Recycling Facility and/or Recycling Containment

Type of action: ☐ Permit
 ☒ Modification
 ☐ Closure

March 27, 2025

RE: Solaris Water Midstream, LLC, Wild Cobra Recycling Facility and Containments
Minor Change to Design Drawings

9-23-24 – Maximum Volume 1,438,493 bbls

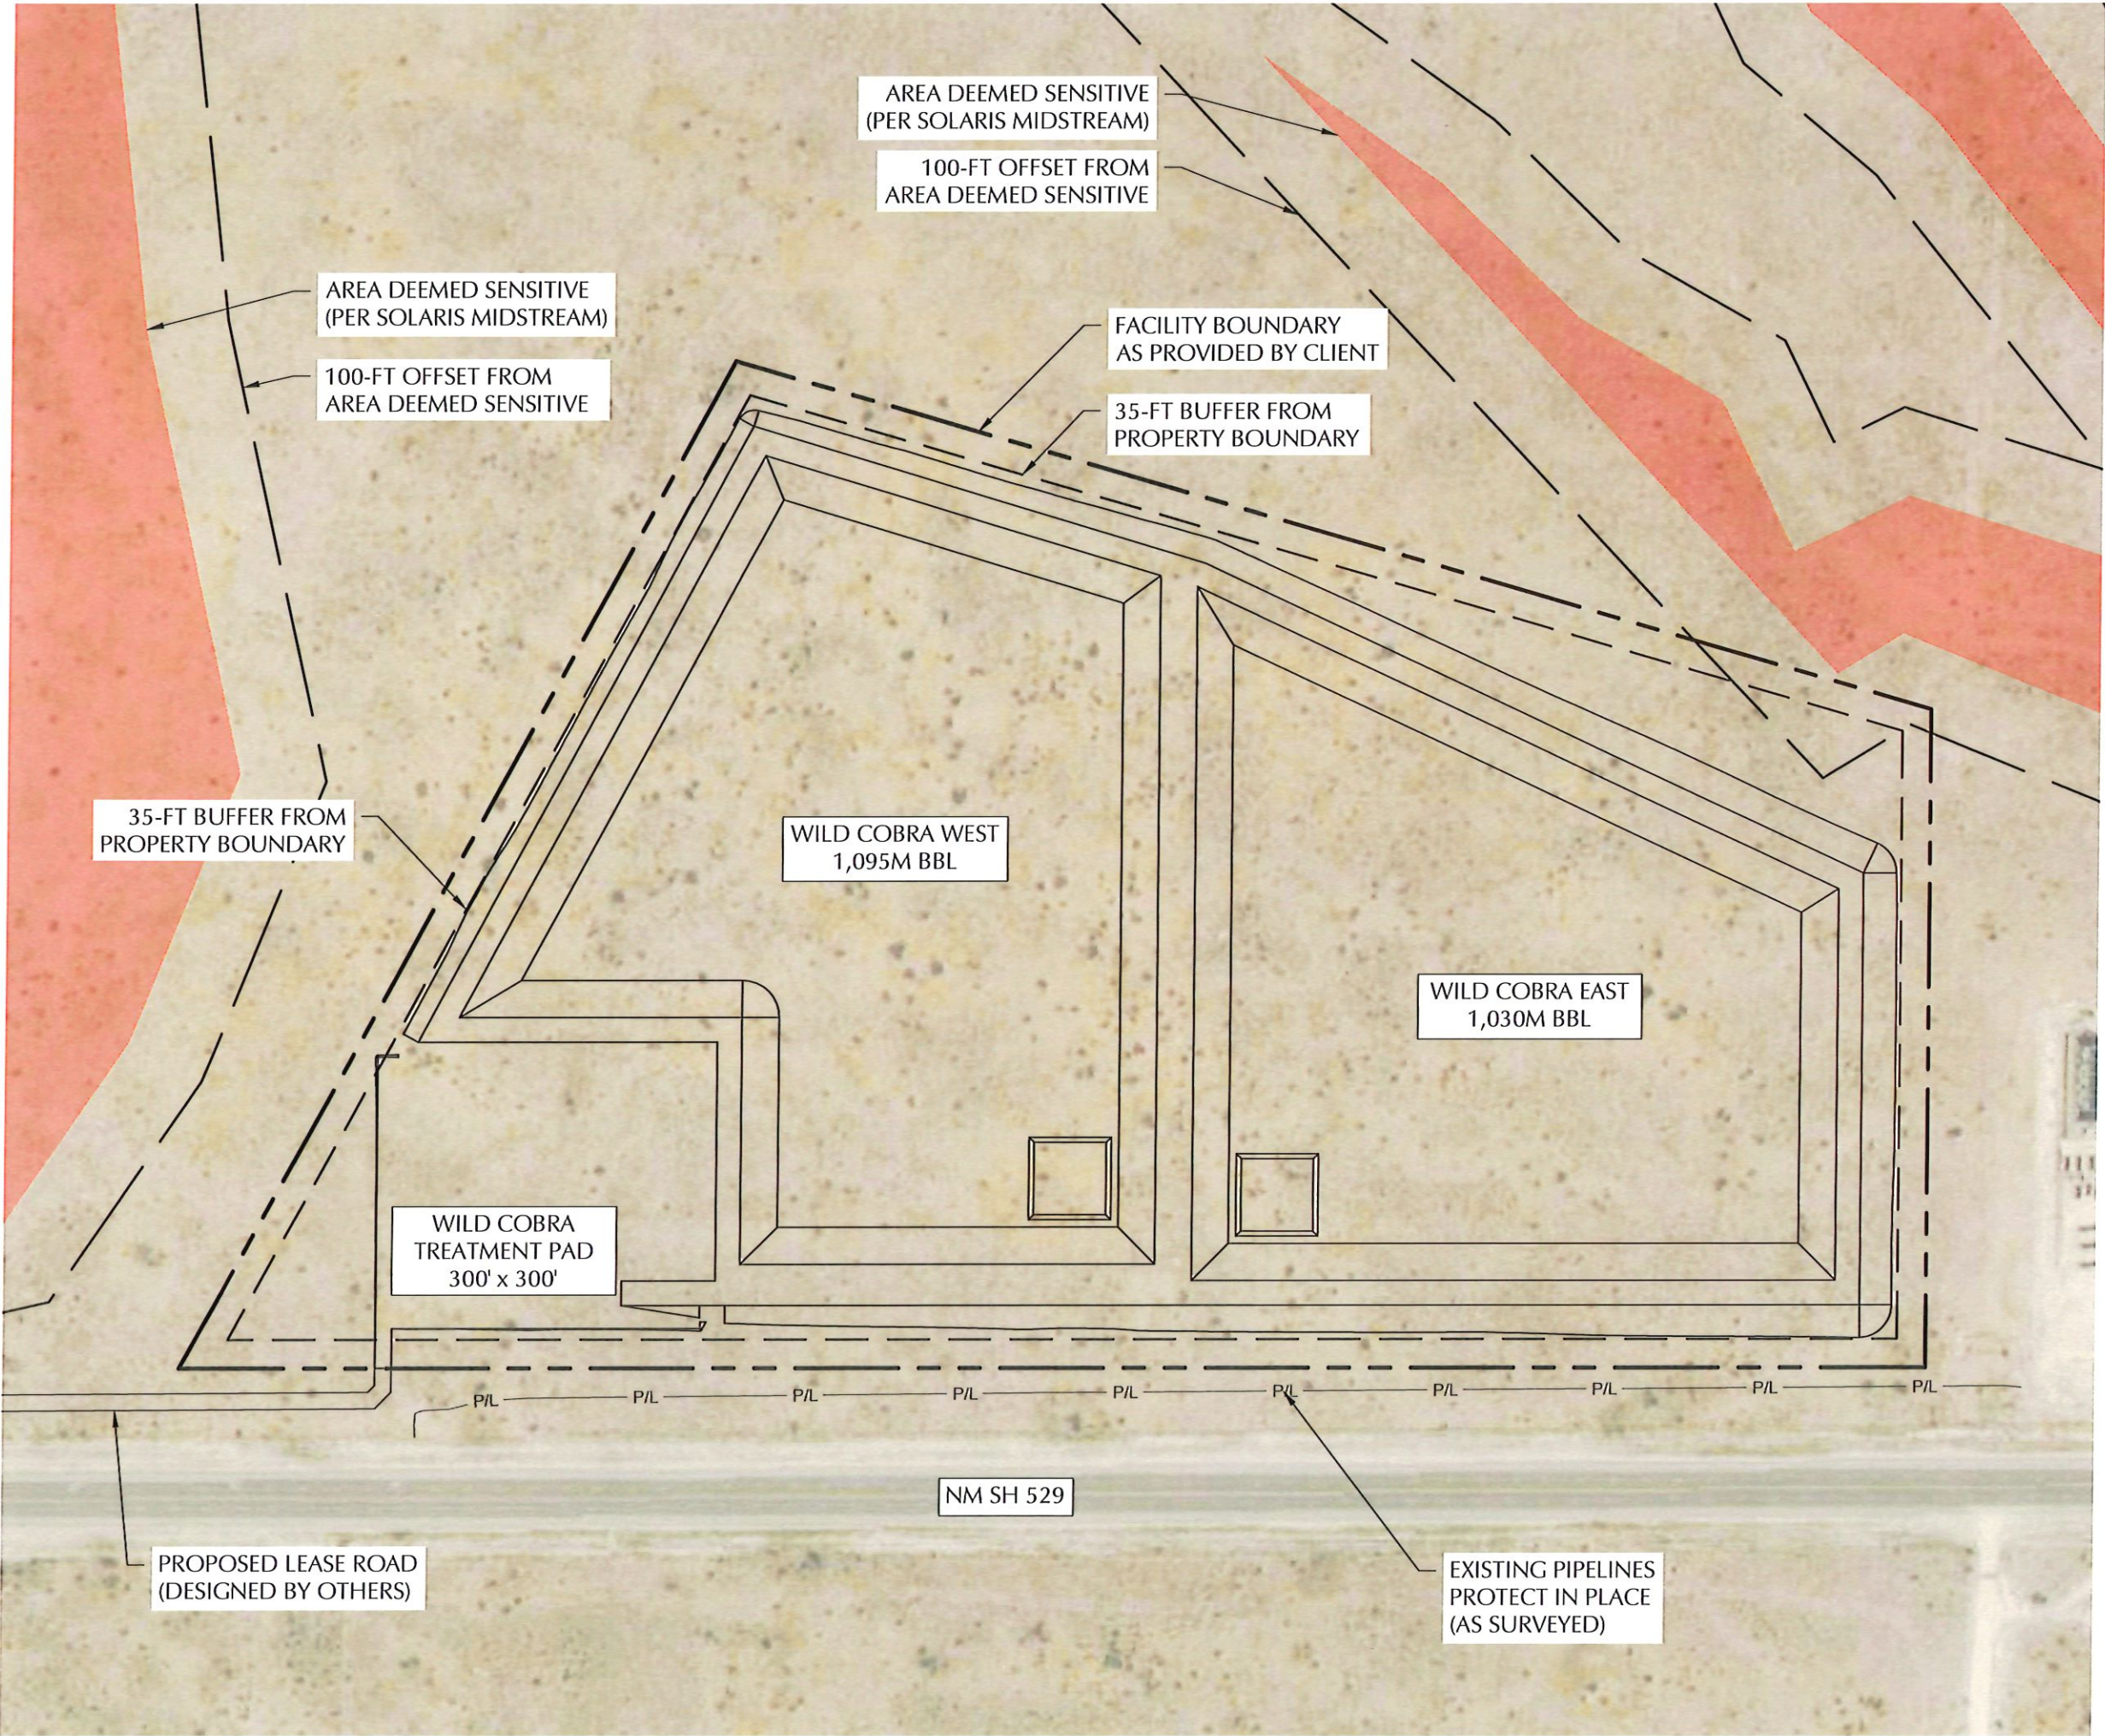
On behalf of Solaris Water Midstream, LLC, R.T. Hicks Consultants prepared this short comparison of the revised design plan dated 3/21/25 to those dated 9/23/24. The State Land Office requested a larger buffer that resulted in a minor modification to the East Containment. Attached are the revised drawings that Solaris will use for construction as these were approved by the SLO. Examination of Page 3 from both plan sets demonstrate the change of design is difficult to discern and both designs lie within area cleared in Volume 1 of the 2024 submission and approved by OCD. .

The revised design moved the northern levee/anchor trench of the East Containment to the south resulting in a decrease of volume shown on the attached page. There is no design change to the West Containment. As this submission is a minor modification of an approved registration, Solaris will begin the construction process as soon as possible.

3-21-25 Maximum Volume 1,298,942 bbls
